ROE PROPERTY SUBDIVISION,
RESUBDIVISION OF LOT 1

Engineering Comments: FINAL PLAT COMMENTS (should be addressed prior to submitting the FINAL PLAT for review and/or signature by the City Engineer):

DETAIL SITE PLAN

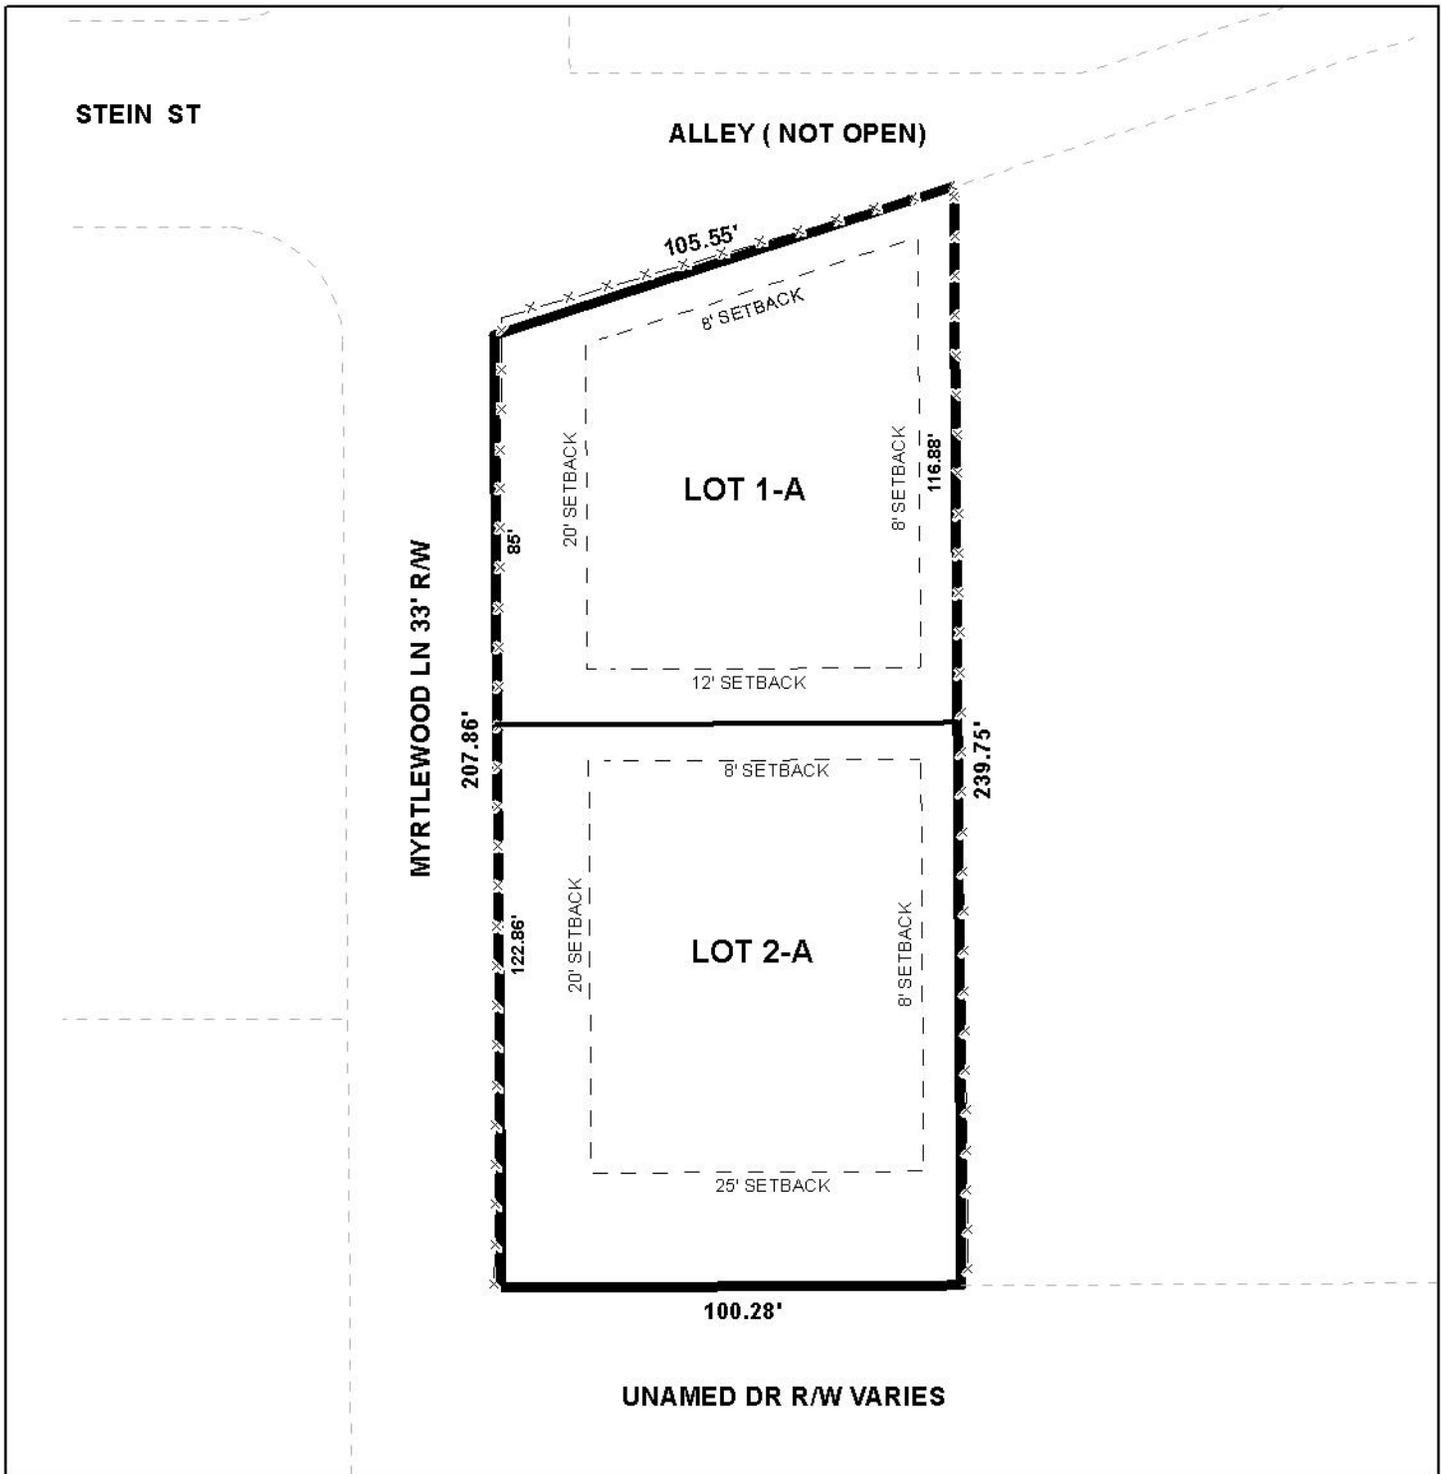
- B. Provide the dimensions of the ROW width for the unnamed ROW on the south side of LOT 2-A.
- C. Show and label the monument set or found at each subdivision corner.

- D. Dedicate the corner radius (25' minimum or as approved by the City Engineer and Traffic Engineer) at the northwest corner of LOT 1-A and southwest corner of LOT 2-A to the City of Mobile, and list the amount of dedicated acreage.

As proposed, both lots have frontage onto Myrtlewood Lane, a minor street with curb and gutter requiring a 50-foot right-of-way width. The preliminary plat illustrates a non-compliant 33-foot right-of-way. As was required in 1980 for the adjacent Sigler Subdivision (also originally a Roe Property Subdivision lot), and in 1988 for Gaillard Oaks, across the street, dedication sufficient to provide 25 feet from the centerline should be required.

Proposed Lot 1-A abuts a public alley (no right-of-way width provided) to the North of the subject property. Historically, this alley provided pedestrian only access between Stein Avenue / Myrtlewood Lane and Avalon Street / Devendel Lane, as a stairway used to exist in the alley due to the change in elevation between the two sets of streets. The applicant has stated a desire to use a portion of the unimproved alley to access a proposed garage, and as such has requested a reduced setback along the alley of 8 feet. The applicant proposes a 12-foot setback on the opposite side, to provide the Zoning Ordinance minimum combined side yard setbacks. As Section V.D.9. of the Subdivision Regulations only provides for a 25-foot setback from abutting street rights-of-way, this section would have to be waived to allow the requested 8-foot setback along the alley. Section V.B.14. of the Subdivision Regulations requires a minimum right-of-way width for alleys of 20 feet, thus the plat should be revised to depict the existing alley width and, if necessary, the dedication of right-of-way to provide the minimum 20-foot width.

be given an address number along Myrtlewood, not the unnamed street. Additionally, the unnamed street appears to provide access to the house located at 114 Myrtlewood. The right-of-way of the unnamed street is indicated as varying, however, plat should be revised to either indicate that the unnamed right of way has existing minimum width of 50', or dedication should be required to provide 25' from the centerline. The applicant could consider requesting a waiver of Section V.D.9. of the Subdivision Regulations to allow for the setback along the unnamed right of way to only be 20 feet, as would be allowed by the Zoning Ordinance.

Dedication of corner radii in compliance with Section V.D.6. of the Subdivision Regulations at both the Northwest corner of Lot 1-A and the Southwest corner of Lot 2-A, should be coordinated with the City Engineer and the Traffic Engineer, if determined necessary. In addition, the revision of minimum building setback lines adjusted for dedication will be required.

It is important to note that the previous plat illustrated a compliant 25-foot front building setback along Myrtlewood Lane for both proposed lots, while the revised plat illustrates a 20-foot front building setback. Lot 2-A also fronts an unnamed drive to its South. The previous plat again illustrated a compliant 25-foot front setback for Lot 2-A along the unnamed drive, which is unchanged on the revised plat.

As for the requested 20-foot reduced setback for Lot 1-A along Myrtlewood Lane, this would not be consistent with previous subdivision approvals by the Planning Commission. It should be noted, however that should the Planning Commission choose to allow a 20' setback along Myrtlewood Lane, a waiver of Section V.D.9. of the Subdivision Regulations will be required for both lots, in addition to a Front Yard Setback Variance for the proposed Lot 1-A. Furthermore, if no dedication is required, a waiver of Section V.B.14. of the Subdivision Regulations will be required.

- 1) Dedication to provide 25' from the centerline of Myrtlewood Lane;*
- 2) Either illustration that the alley abutting Lot 1-A has a minimum 20' right-of-way, or dedication to provide 10' from the centerline, as necessary;*

- 3) Coordination with the City Engineer and the Traffic Engineering regarding the provision of a corner radius in compliance with Section V.D.6. of the Subdivision Regulations at both the Northwest corner of Lot 1-A and the Southwest corner of Lot 2-A, if a radius is determined necessary;*

- 4) Revision of the Final Plat to illustrate a 25-foot front setback along Myrtlewood Lane for both lots, adjusted for dedication;*
- 5) Retention of the 8-foot setback from the alley on the North side of proposed Lot 1-A, adjusted for dedication;*

- 6) Retention of the 25-foot setback from the unnamed drive to the South of Lot 2-A;*
- 7) Retention of the lot size in both square feet and acres, or the furnishing of a table on the Final Plat providing the same information, adjusted for dedication;*
